Access Compliance Report

Public Rights-of-Way

(Curb Ramps)

Intersection ID: 14455	Main Street: EAST_BV	Cross Street: WINTHROP_AV	Location: SW
ADA ID: F32FE6D8641A	Ramp Type: Perp	Initial Pass/Fail: Fail	Overall Compliance: No
Severity Score: 1.25			
Codes/Mitigation Info/Possible Solution		Field Measurements/Component Compliance

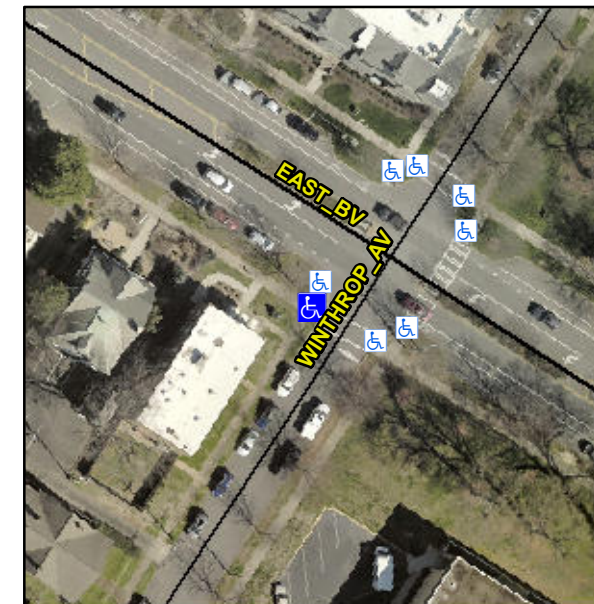
Not Found, R304.5.3

Compliance	Description	Data	Compliance	Description	Data
N/A	Ramp Length (in)	58.0	Yes	Ramp Slope (%)	7.9
Yes	Ramp Width (in)	72.0	No	Ramp XSlope (%)	3.6
N/A	Flare Type LT	N/A	N/A	Flare Type RT	N/A
N/A	Flare Slope LT (%)	N/A	N/A	Flare Slope RT (%)	N/A
N/A	Flare Traversable LT?	N/A	N/A	Flare Traversable RT?	N/A
N/A	Landing Length (in)	N/A	N/A	DWS Provided?	N/A
N/A	Landing Width (in)	N/A	N/A	DWS Contrast?	N/A
N/A	Landing Slope (%)	N/A	N/A	DWS Length (in)	N/A
N/A	Landing X Slope (%)	N/A	N/A	DWS Full Width?	N/A
N/A	Landing Curb? (Y/N)	N/A	N/A	DWS Offset (in)	N/A
N/A	Shared Landing?	N/A			
N/A	Gutter Ponding?	N/A	N/A	Gutter Slope (%)	N/A
N/A	Gutter Lip Ht (in)	N/A	N/A	Gutter X Slope (%)	N/A
N/A	Painted X Walk1?	Yes	N/A	Painted X Walk2?	N/A
	X Walk 1 Direction	To SE		X Walk 2 Direction	N/A
N/A	X Walk 1 Width (in)	110.0	N/A	X Walk 2 Width (in)	N/A
	X Walk 1 Slope (%)	0.3		X Walk 2 Slope (%)	N/A
	X Walk 1 X Slope (%)	3.6		X Walk 2 X Slope (%)	N/A

Remove & Replace Entire Ramp.
